MEMORANDUM

March 14, 2025

SUBJECT: University Boulevard Corridor Plan  
Public Hearing Draft – Department of Transportation Comments

**SUBJECT:** University Boulevard Corridor Plan  
Public Hearing Draft – Department of Transportation Comments Follow-up

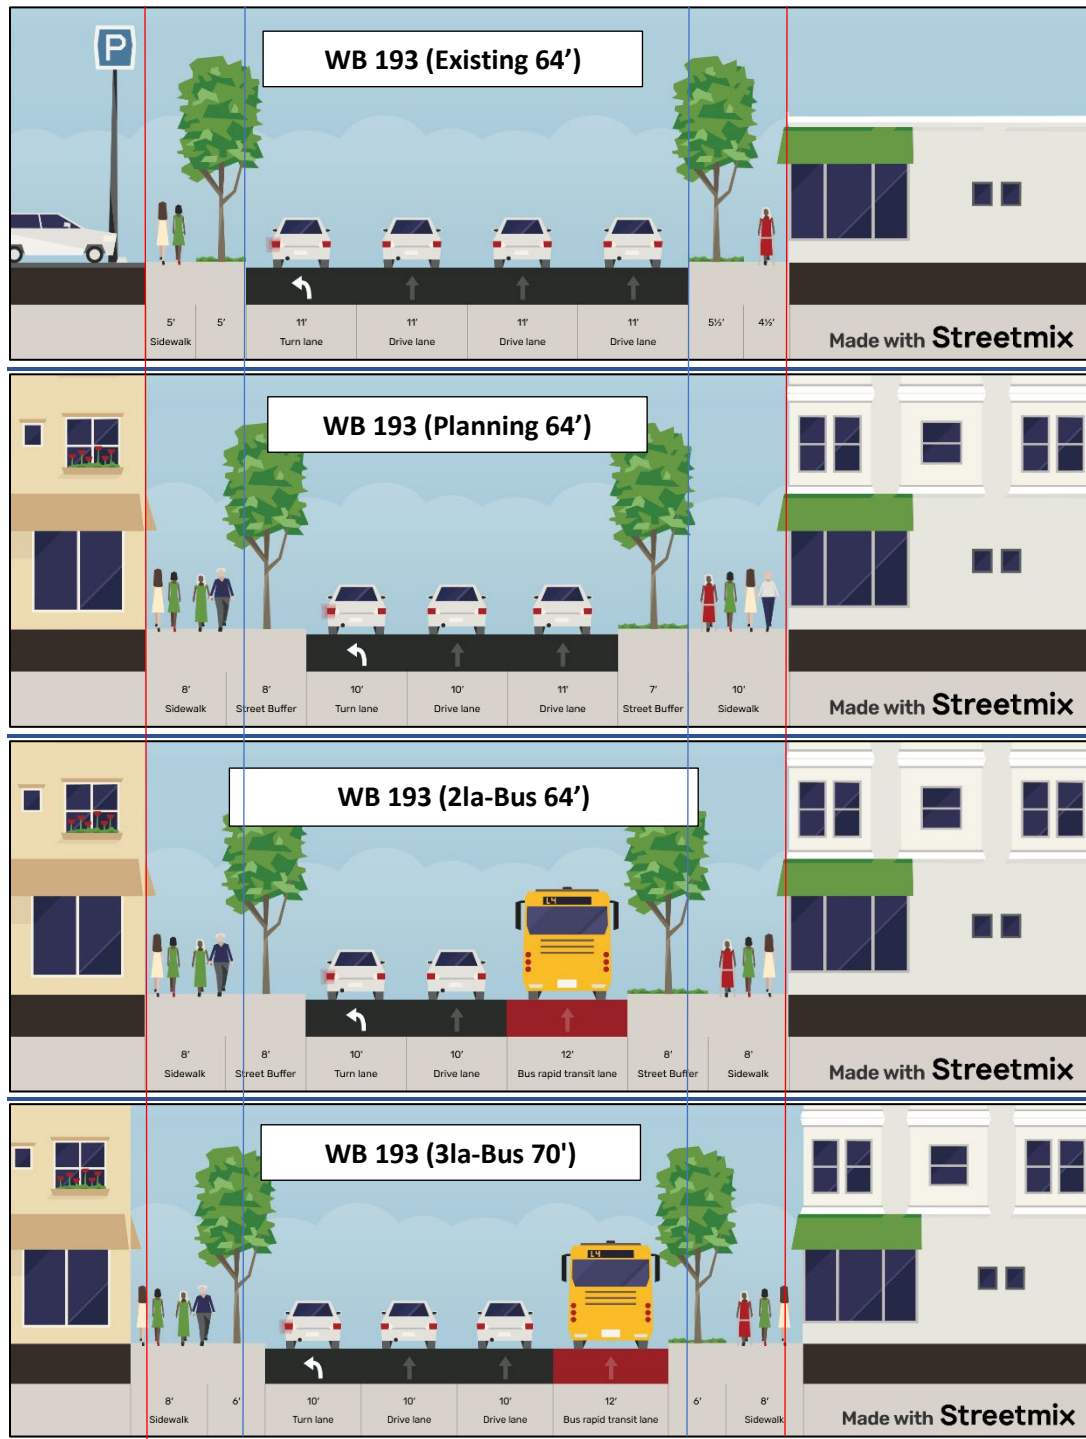
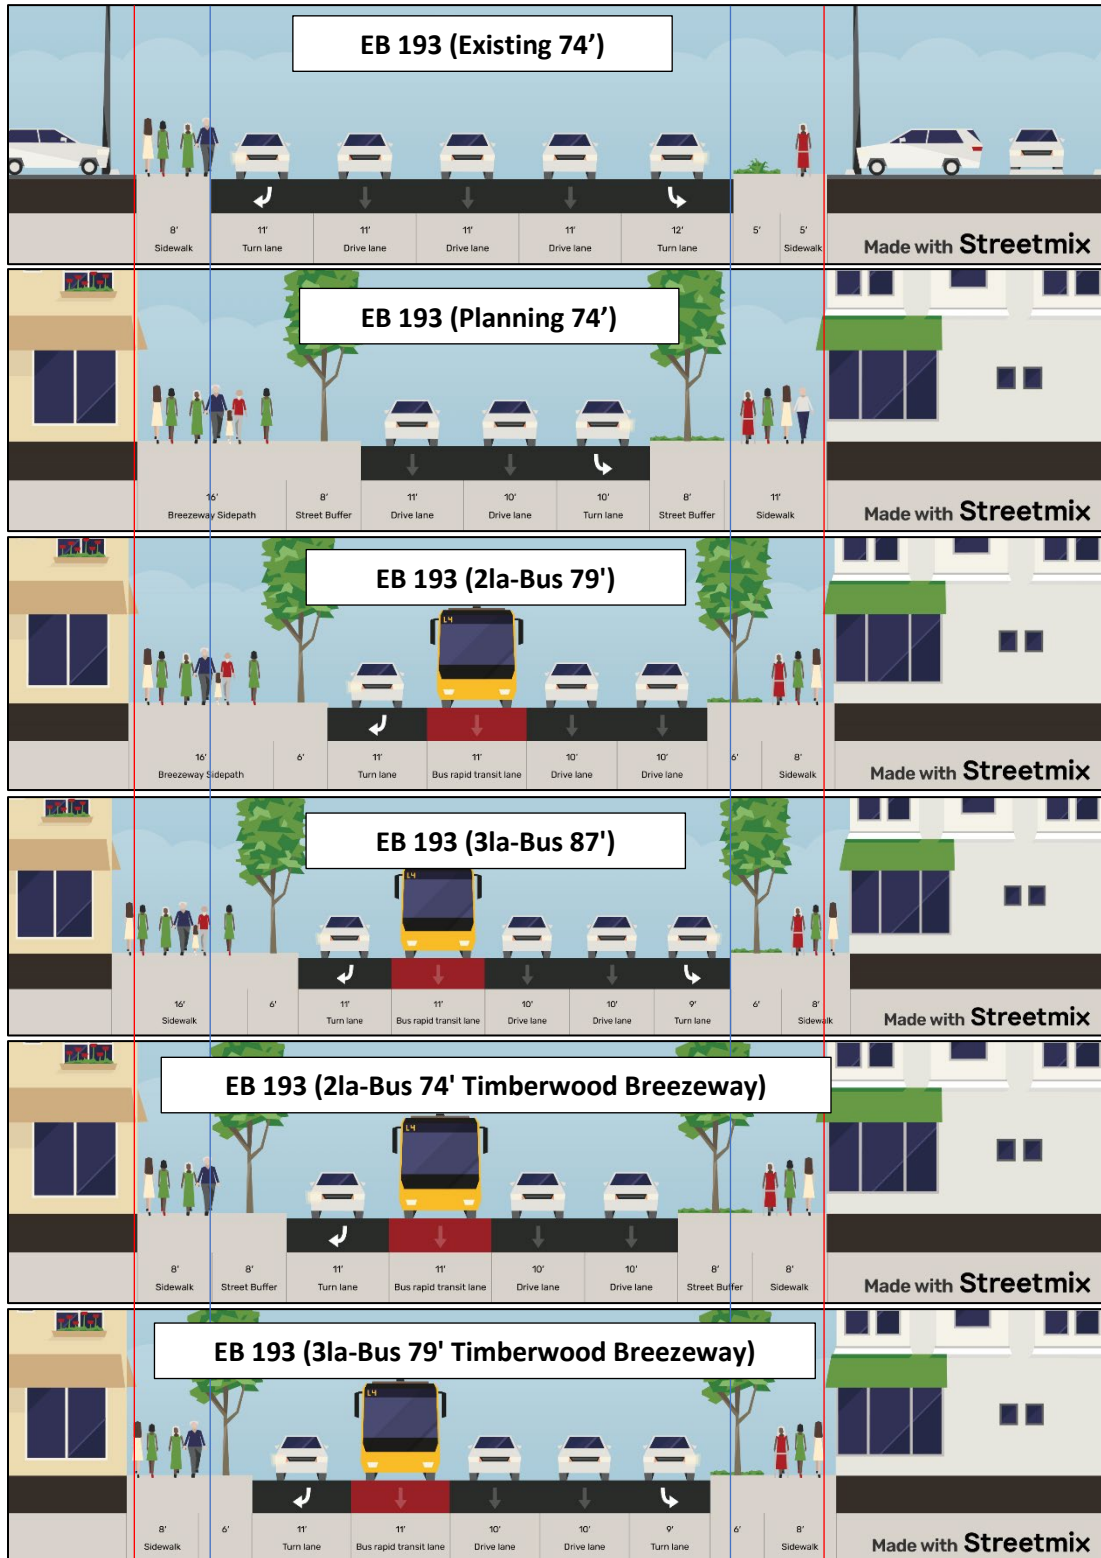
- 1) **TRANSIT LANES IN FOUR CORNERS:**<sup>18,19,30</sup> We strongly recommend that dedicated bus lanes be provided through Four Corners. Bus lanes are among our top priorities through Four Corners as this corridor already carries very high passenger volumes and provides important regional connectivity. Recent ridership data from WMATA shows ridership almost 40% above pre-pandemic levels. The County worked with the State to install dedicated bus lanes along the portion of University Boulevard between Amherst Avenue and Dennis Avenue. Extending these bus lanes through Four Corners will enhance the current investment in prioritizing transit along the corridor. These lanes will support other goals of the plan, including:

The cross-sections on the next two pages offer some potential options. In the westbound direction, our preference is for an additional bus lane necessitating +3’ on each side of the rights-of-way. In the eastbound direction, our preference is for an additional bus lane and a dedicated right-turn lane (as to remove right-turns from the bus lane), necessitating +6.5’ on each side of the rights-of-way.

Additional width beyond the existing rights-of-way can come from easements rather than dedication. While we appreciate the interest to keep the visual nature of the corridor narrowed as much as possible, we do not believe that the additional widths compromise this interest in our efforts to achieve other plan goals.

If necessary for additional space: consider potential bikeway options parallel to University Blvd which might accommodate Breezeway-level design parameters. One such option might use Timberwood Avenue, transitioning at the west through North Four Corners Local Park, and at the east via Pierce Dr / Lexington Dr. (shown in **blue** in the graphic below)

- 3) **PED-BIKE CONNECTIONS:**<sup>33-36</sup> Consider adding the following additional connections as ped/bike hard surface trails, with accompanying Shared Road & Trail bikeways following these paths parallel on each side of University Boulevard: *(shown in blue in the graphic below)*

- Linking Gilmore Drive's discontinuities, including through the Mary's Center property as well as the properties just east of Dennis Avenue.
  - Linking Gilmore Drive and Whitehall Street.

- Linking Whitehall Street and Breewood Road.
  - Linking Edgewood Avenue and Whittington Terrace, passing through the Luther Rice Memorial Baptist Church site.

- Linking Whittington Terrace and Arcola Avenue, passing through the Northwood High School site.
